From: FNAL::JBS 21-MAY-1991 21:53:25.07
To: DELCHAMPS, GOURLAY, KOSKA, JAFFERY, LAMM, WAKE
CC: MYSELF
Subj: DSA323 End Force and the "unusual" quench behavior

TSS-SSC 91-095

DSA321

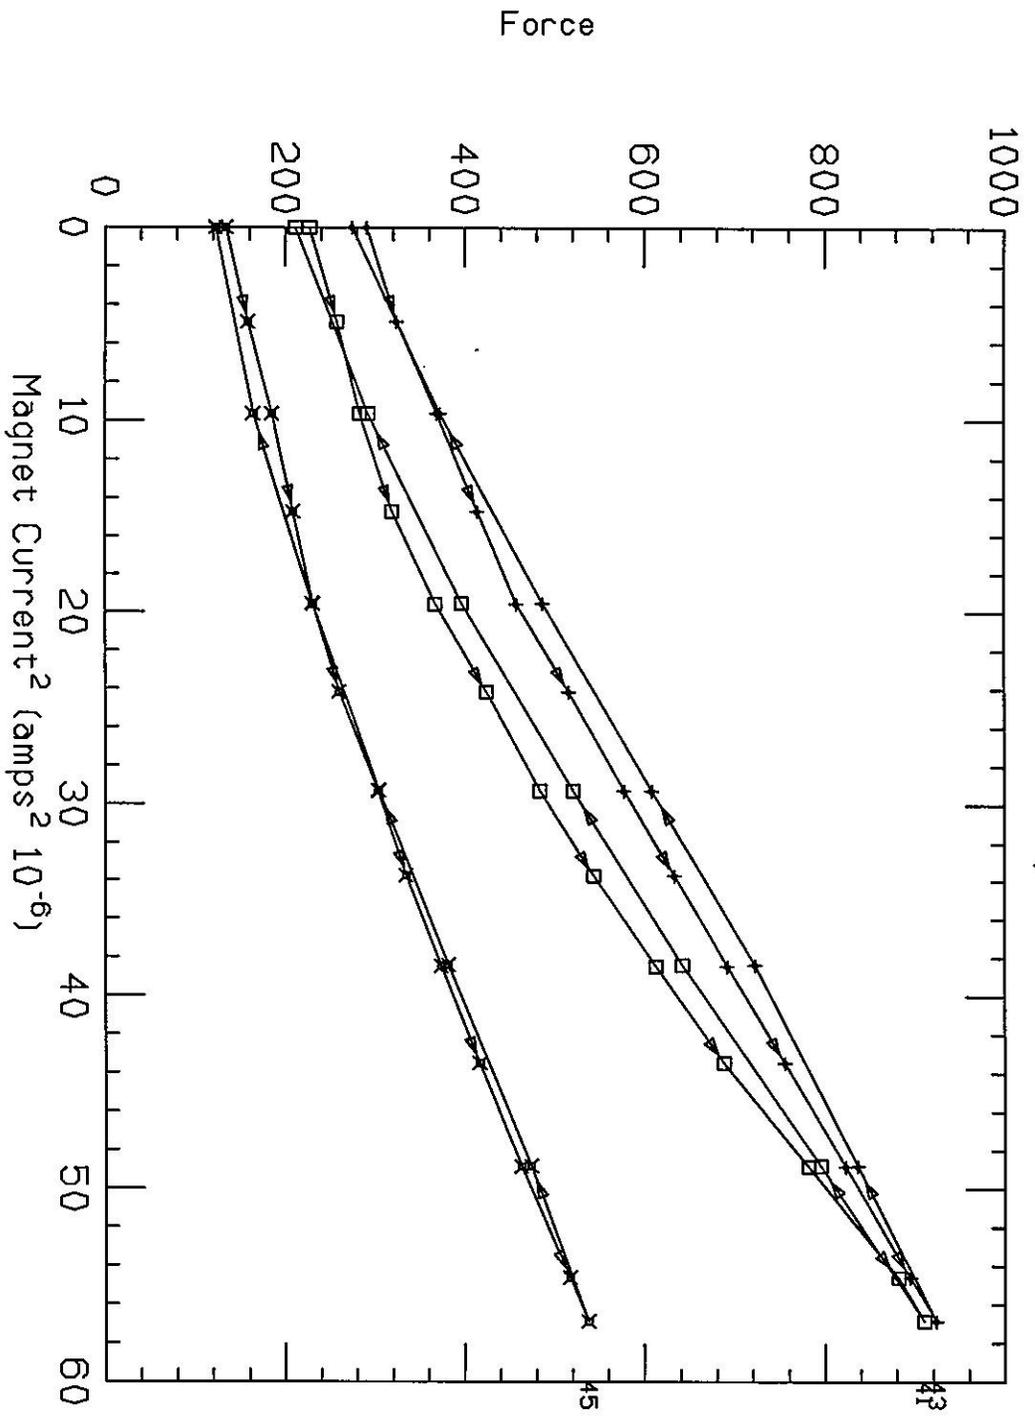
Perhaps the problem with DSA323 is inadequate end loading. Several magnets at BNL have shown relatively poor quench performance when the end pre-load was too low. (Of course at least one short magnet at each Lab has worked well without end preload as well.) The bullet gauges on DSA321 showed a substantially smoother, more linear, and steeper slope with excitation than those on DSA323. (I attach TopDrawer plots of "typical" data from each magnet.) Although it will slow further the test schedule in Lab 2 I think that we ought seriously to consider doing one more thermal cycle on this magnet. When the magnet is warm we would tighten the return end bullets to, say 500 lbs force per bullet, up from the 200 lbs apiece that we normally use, and tighten the lead end set screws to the same torque used to set up the return end bullets. This offers us an opportunity to learn something about the importance of end loading.
